September 24, 1981
L-81-420

Re: St. Lucie Unit 2
Docket No. 50-389
Final Safety Analysis Report
Requests For Additional Information

Attachment to L-81-420
September 24, 1981

APPENDIX 15C-4

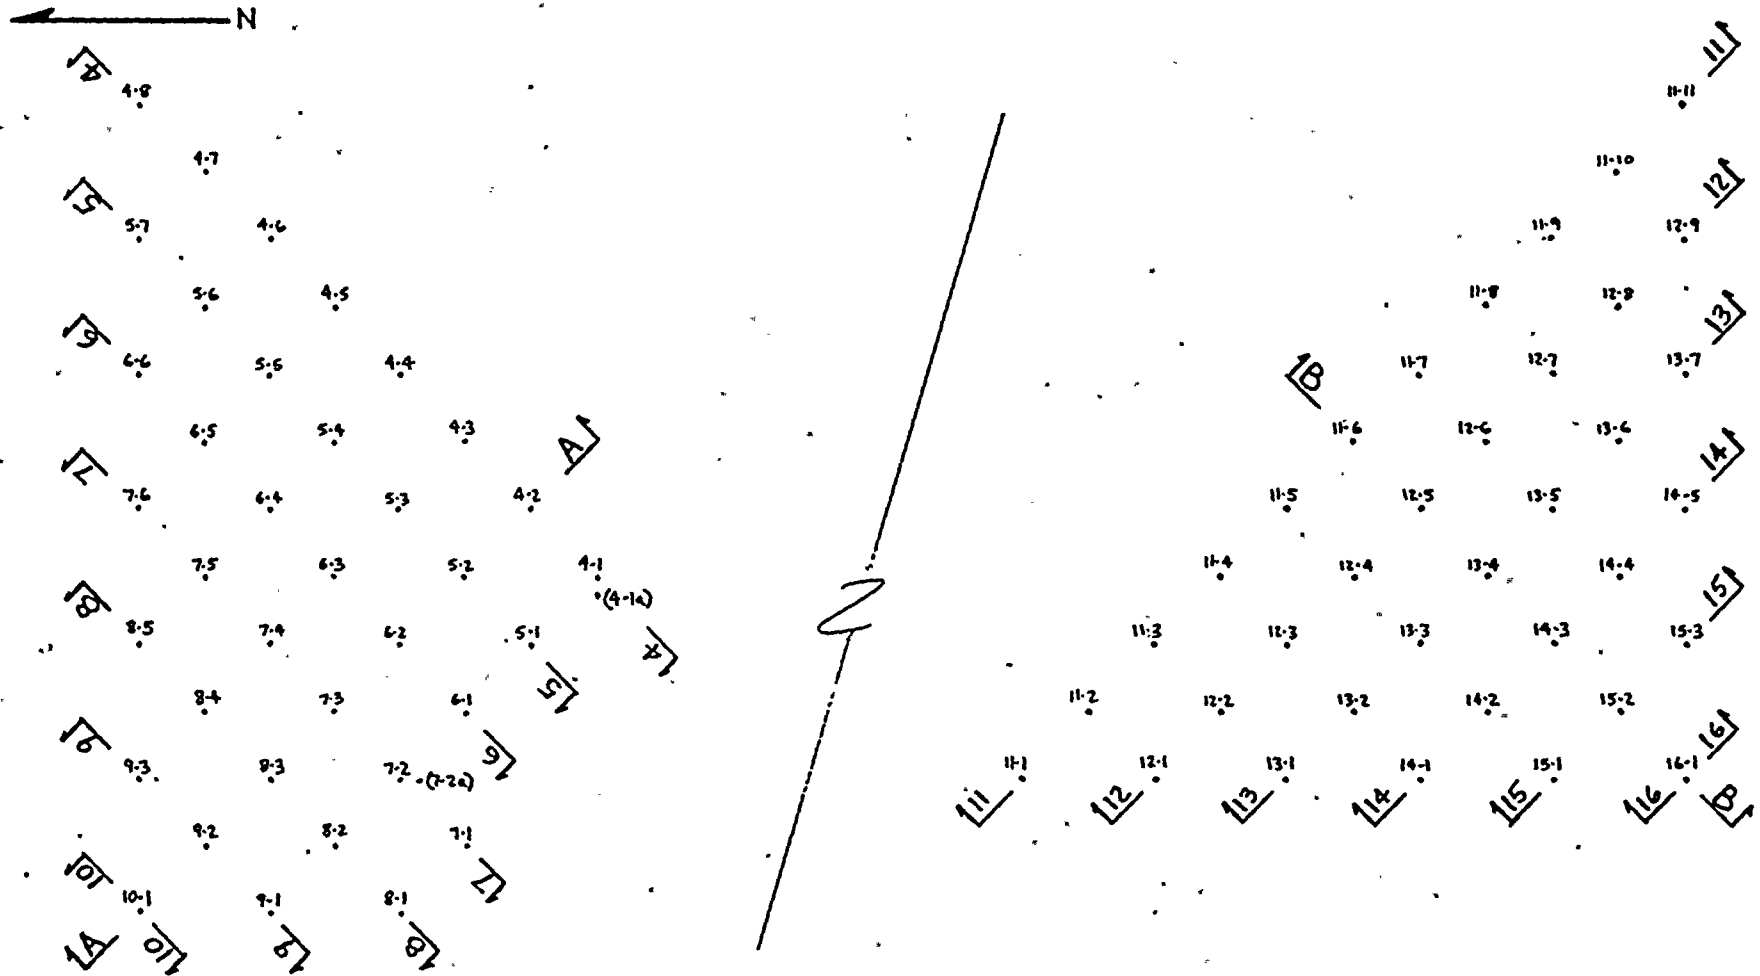
- 4) The attached figure presents our calculation for factors of safety against liquefaction in the areas north and south of the intake structures, in the insitu soils. The factors of safety have been calculated for relative densities of 60.8, 73.3 and 80%. These relative densities were based on values obtained during our earlier investigation in the area. The 73.3% is the average relative density and 60.8% is one standard deviation less than the average. These values are presented in the SL2 PSAR Appendix 2G. In addition, we show the safety factor for a relative density of 80%. This 80% is a conservative lower bound based on the increase due to dewatering alone or due to compaction by pile driving alone. In any case, using the procedures outlined by H.B. Seed, the minimum safety factor against liquefaction in the insitu soil is greater than 2.2 for any depth for any possible relative density and ranges up to a value of 3.7 safety factor.

FIGURE 1
 CONTAINMENT PAN COOLERS
 TORQUE AND CURRENT VS SPEED AT 80% VOLTS
 TYPE PH INSULATION

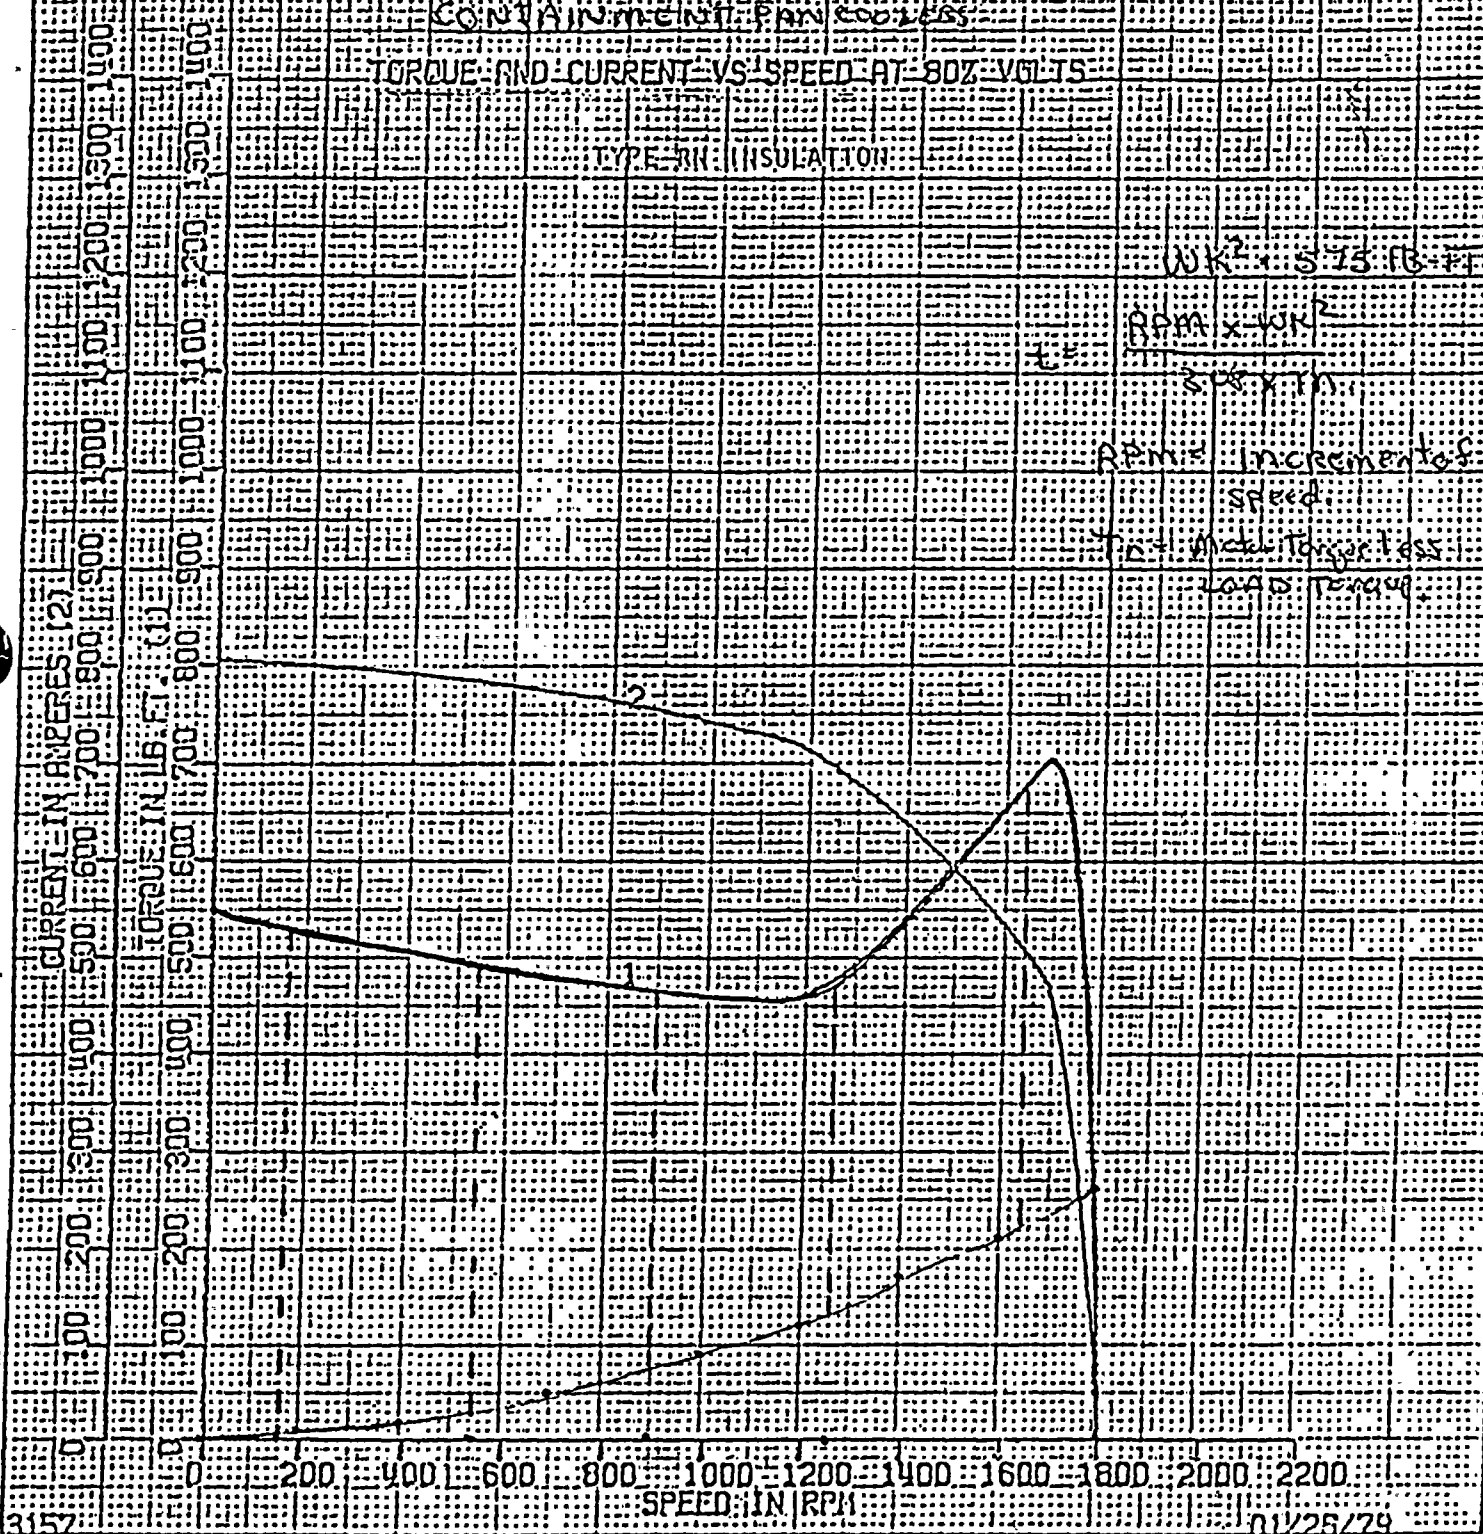
To assure that the motor has sufficient torque to accelerate the driven equipment under this type of transient, the motor manufacturer supplied speed torque curves for motor acceleration considering a constant motor terminal voltage of 80% which is bounding to the starting transient described above. This curve is shown in Figure 1. From this curve net torque (motor torque minus loading torque) was determined at 20% speed intervals and the acceleration time of the motor was calculated to be 7.6 seconds. Comparing this acceleration time to the acceleration time measured in the accident analysis, 10 seconds, indicates that the motor is accelerated in sufficient time as to not impact the accident analysis. To assure that the motors are not damaged during this starting transient, the motor acceleration time was compared to the safe stall time of the motor. From manufacturer's data applied, the safe stall time at 100% starting voltage is 11 secs. (hotstart). The acceleration time of 7.6 secs. is less than 11 seconds and therefore motor damage will not occur. It must be noted that the safe stall time of a motor increases as a result of lower starting voltage since the inrush current is less. Therefore, by comparing the acceleration time at the lower voltage (7.6 seconds) to the safe stall time at the higher voltage (11 seconds) is very conservative. Actual manufacturers data for starting transients such as described above indicates that the safe stall time is increased to 15 seconds.

Figure - 1

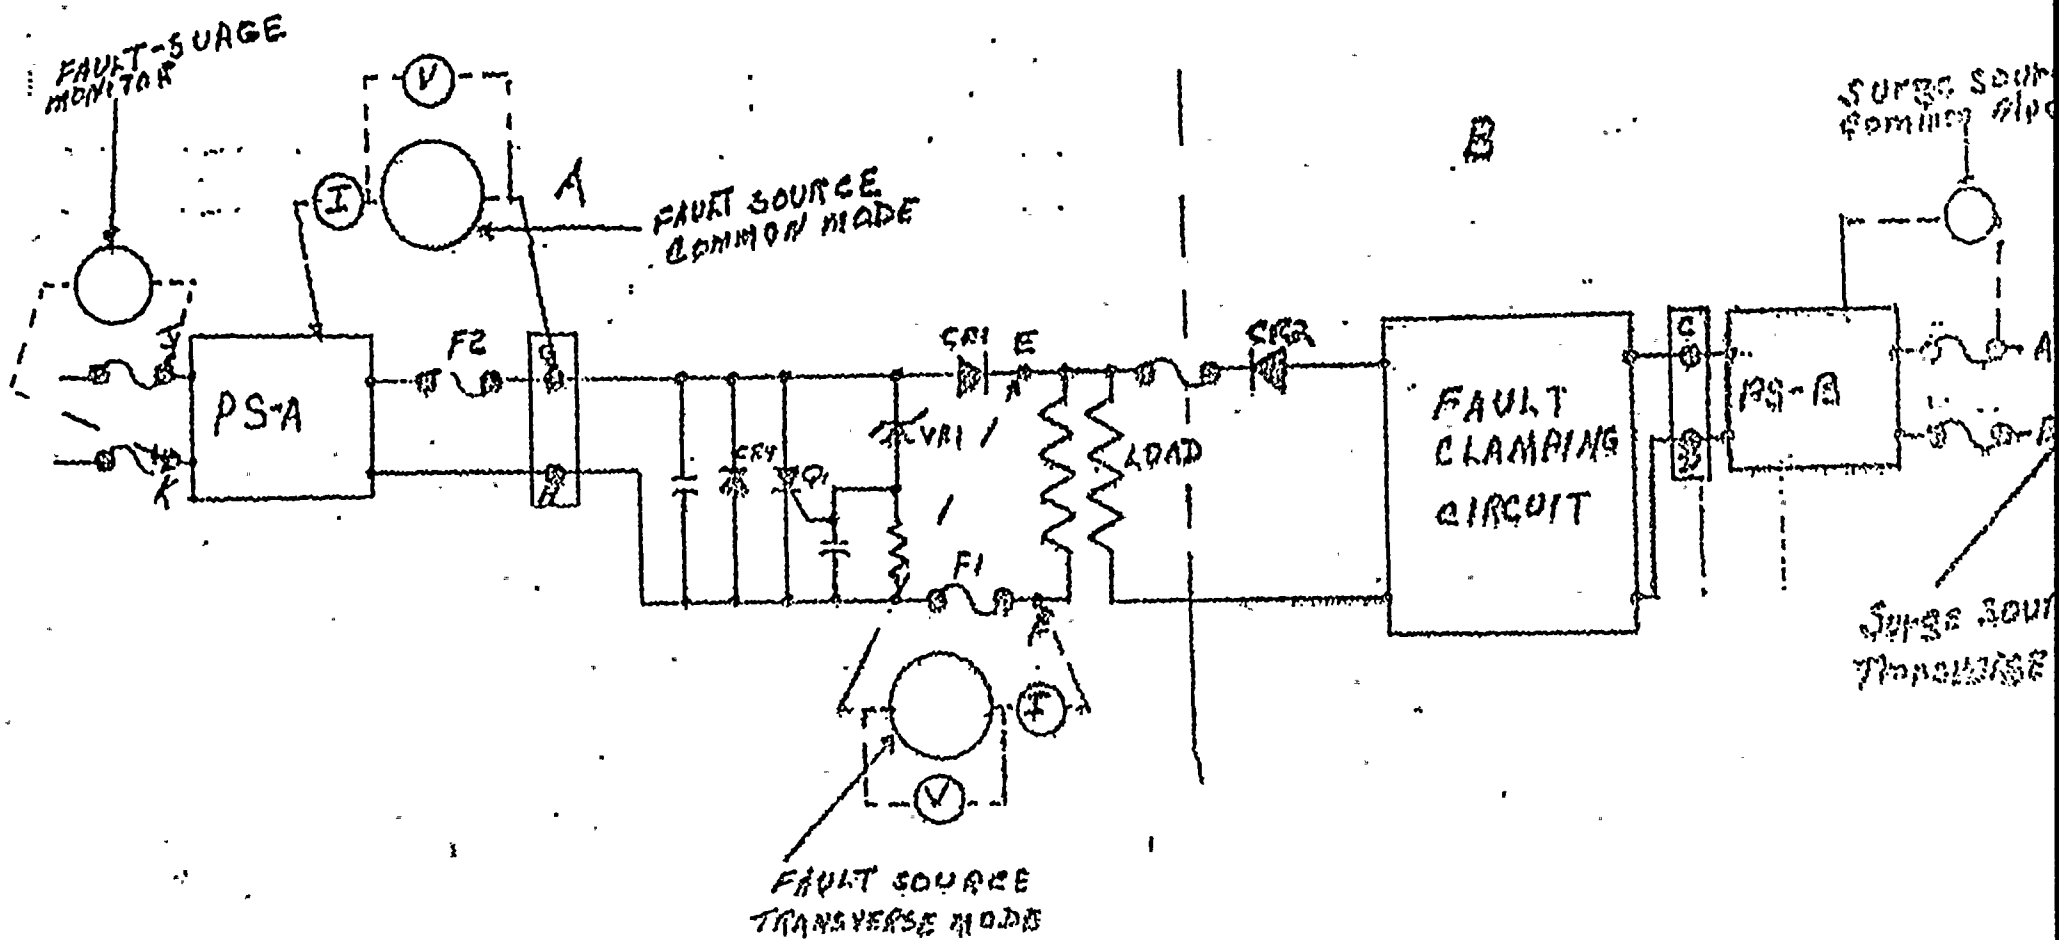
Matrix power supplies and isolation circuits are configured within the RPS as shown in Figure 1. The isolation test will consist of the application of a 600 Vac and 400 Vdc fault in the circuit in the common and transverse modes. The basis for the 600 Vac and the 400 Vdc test voltage is as follows:

For the purpose of this test, it has been conservatively assumed that it is a fault appeared on vital bus B (points A or B to chassis ground in Figure 1) it

would propagate through the DC power supply (PS-B) and appear at points C or D. Since PS-B is directly connected to PS-A (through CR-1 and CR-2) the fault is assumed to appear at points G or H to ground. Therefore, it is required to show that when a fault is present on the BC side of a matrix power supply it does not propagate to the 120 Vac side of the power supply, thereby affecting more than one vital bus. It should be noted that complete propagation of a fault from power supply primary to secondary is a conservative fault circuit evaluation which would most likely not occur.

Similar to the common mode test, a fault appearing on vital bus B (Figure 1 points A and B) is assumed to propagate completely to points E and F. Therefore, it must be shown that application of a fault to the output of the isolation circuit (points E and F) does not propagate in the 120 Vac side of power supply A thereby affecting more than one vital bus. It should be noted that the isolation circuit clamps the fault voltage such that power supply damage does not occur, as discussed below:

Clamp Circuit - The power supply fault clamp circuit is designed to limit or shortout a positive or negative fault. Figure 1 is a schematic of the fault clamp circuit which is connected to each matrix power supply. During normal operation VRI is in the open circuit condition, SCR-Q1 is deenergized and CR4 is reverse biased. The normal 28 Vdc output of the power supply will be seen between points E and F.

1. Common Mode Test (Figure 1)

The common mode test is accomplished by applying a surge to the AC side of the matrix power supply between point (A) and the power supply chassis. During surge application the simulated RPS circuit is operated to show proper function and accuracy. Also, the 120 Vac line of the associated power supply is monitored across points (J) and (K). The same process is repeated for point (B) and the power supply chassis.

2. Transverse Mode Test (Figure 1)

The transverse mode test is accomplished by applying a surge to the AC side of the matrix power supply between points (A) and (B). During application of the surge the simulated RPS circuit is operated to show proper function and accuracy. Also the 120 Vac line of the associated power supply is monitored across points (J) and (K).

Figure -2.

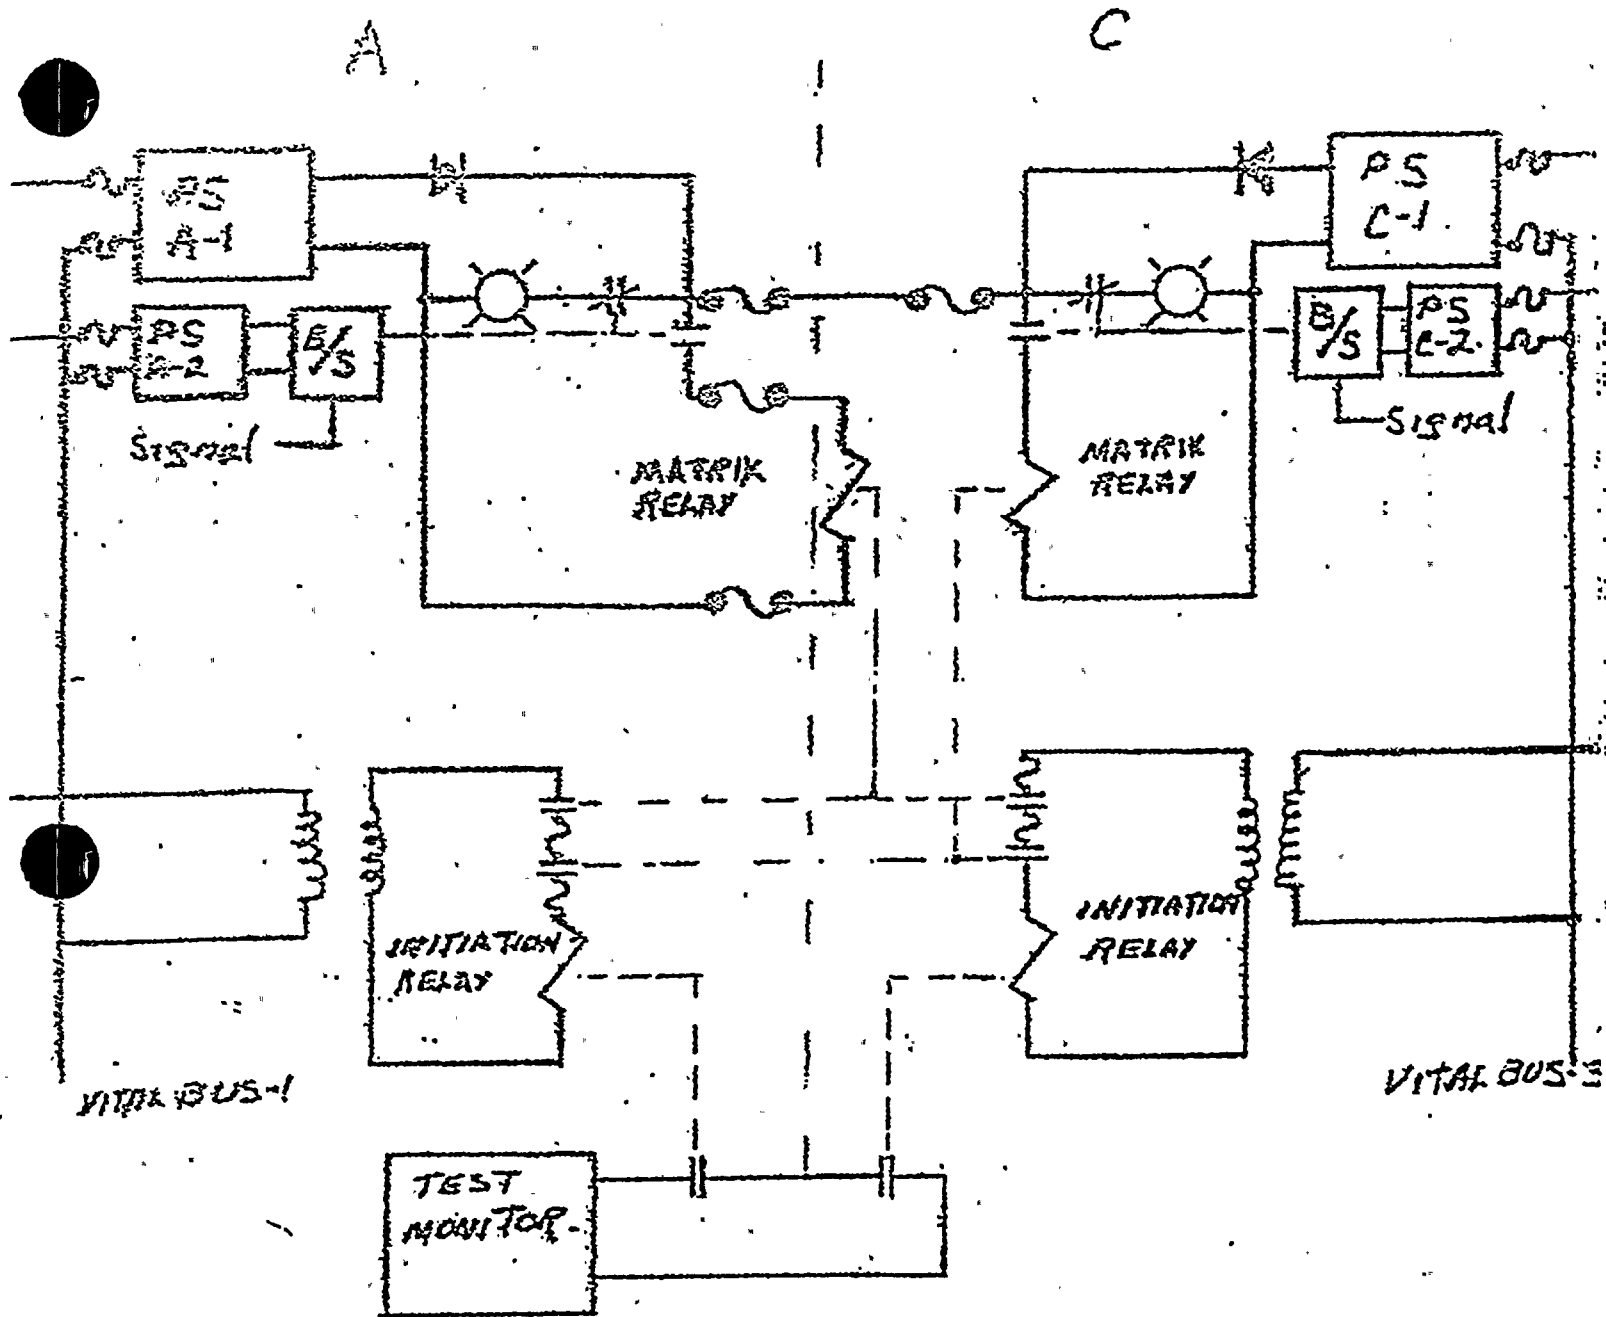
The test involves simulating (with identical equipment) a typical RPS matrix (Figure 2) including bistable trip units, bistable power supplies, matrix power supplies, matrix relays, and isolation relays. Vital bus power (120 Vac) is simulated by using two power isolation transformers. A 300 Vac surge (negative peak to positive peak) will then be superimposed on one vital bus. Thus, the test voltage from neutral to peak will be 337 volts ($120 \text{ Vac} + 10\%$) $\times 1.414$ plus the neutral to peak surge $300\text{V}/2$. The surge voltage is based on a calculation performed for the ANO-2 PPS which concluded that circuit damage or false operation would not occur provided the peak AC voltage is maintained below 400 Vac. Since the equipment within the St. Lucie Unit 2 PPS is similar (but not identical) to the ANO-2 PPS it is assumed that calculation conclusions are applicable to the RPS.
